Lupton 3459 Adjustments

Revised Narrative for Municipal Application 5/12/2020

Lupton Residence 3459 Lakeview Lane

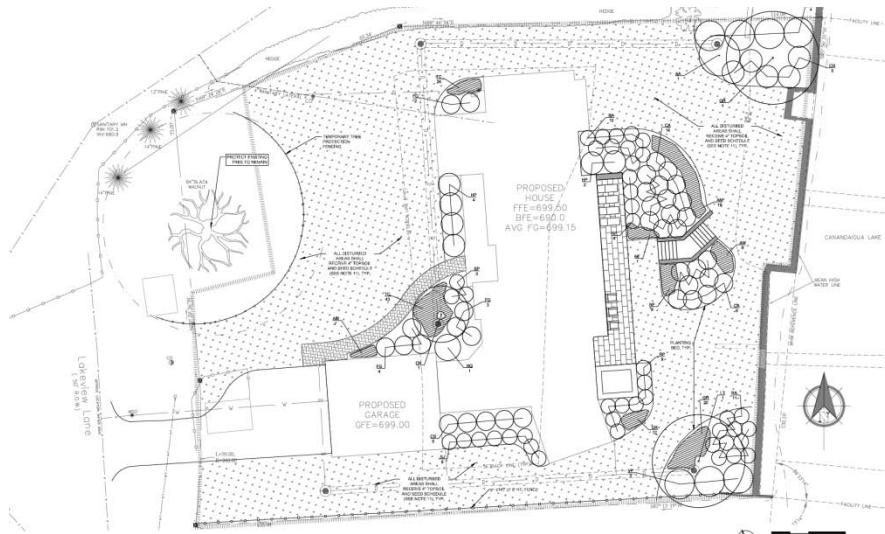
- Reduced the basement from 8.5 feet to a 4 foot crawl space. Eliminated walk out, door/windows at walk out, eliminated extensive hardscape, softened the grade to the lake, reduced the stone veneer on the outside - lower northeast corner of the house, reduced excavation and concrete work while improving the condition of the basement relative to the flood plain.
- Reduced Laundry room and attic above by 120 sq ft.
- Removed the 22.5 degree angle from the porch and reduced the porch by 100 sq ft. Allowing a simpler design on the porch which generated significant savings.

May 10 Landscape Plan

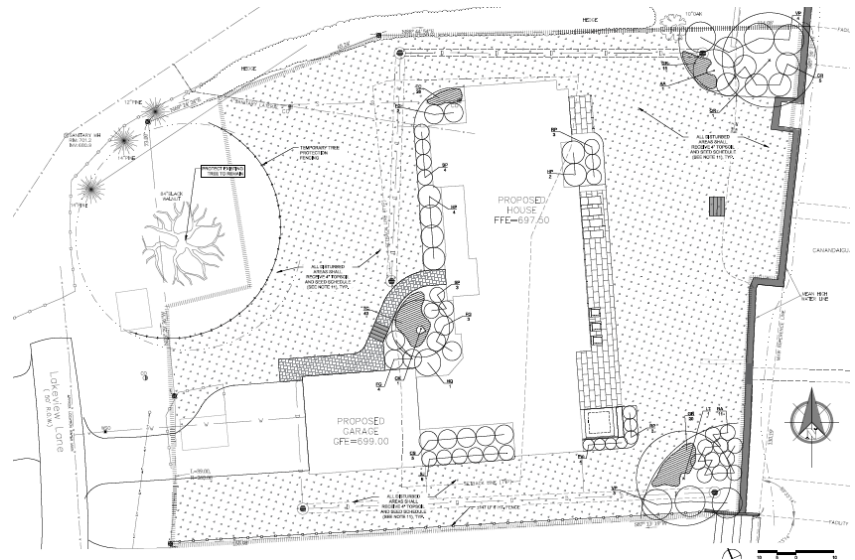
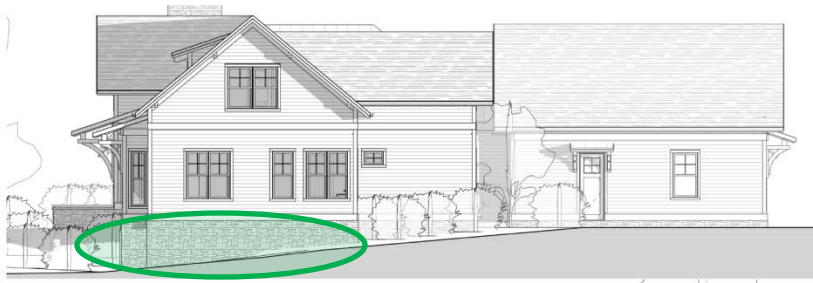
The basement was reduced to a crawl space, the home was lowered on the land by two feet. (699.5 to 697.5) The grade is more gradual throughout the site. Many steps and a great deal of hardscape were eliminated. As the hardscape is gone and no longer needs to be screened, the site is now a gradual lawn. The Shoreline View has been dramatically improved.

The basement was reduced to a crawl space, allowing us to better manage the grade and eliminate the need for many of the steps in the front lawn. It is an easier transition to the lake with less grade and less hardscape. As the hardscape is gone, it no longer needs to be screened. The view is softer in relation to the Shoreline Guideline. There are no other significant changes to the landscape.

May 10 Reduced Floor Plan

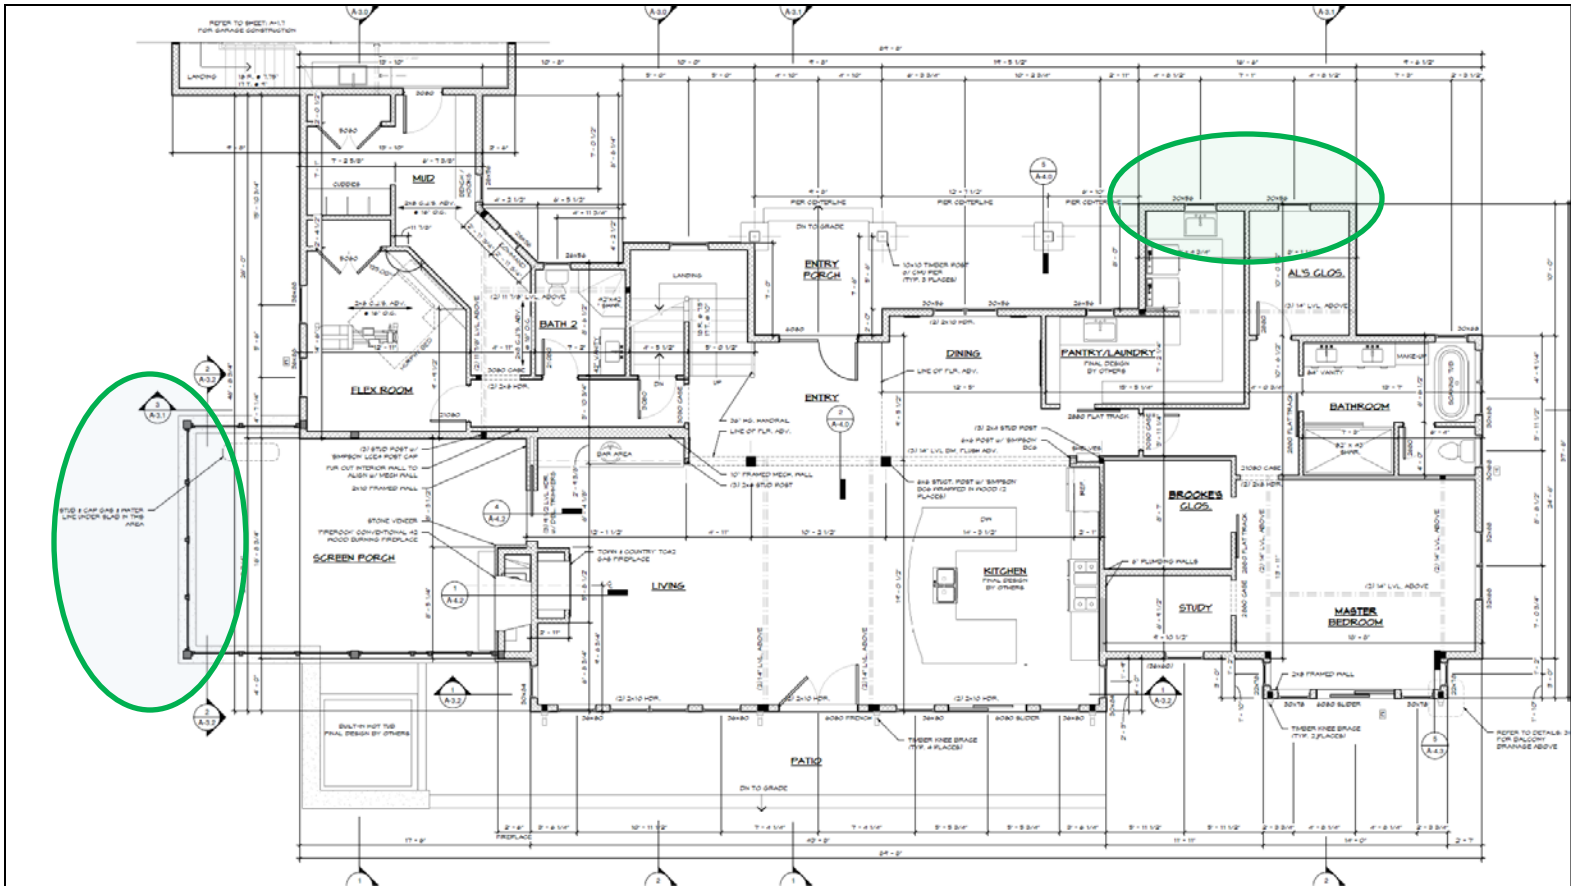
Beyond changing the basement to a crawl space, we also reduced the screened porch by 100 sq ft at the south end and reduced the size of the Laundry Room and Attic above by 60 sq ft on each level. There is no significant change in appearance from the outside.
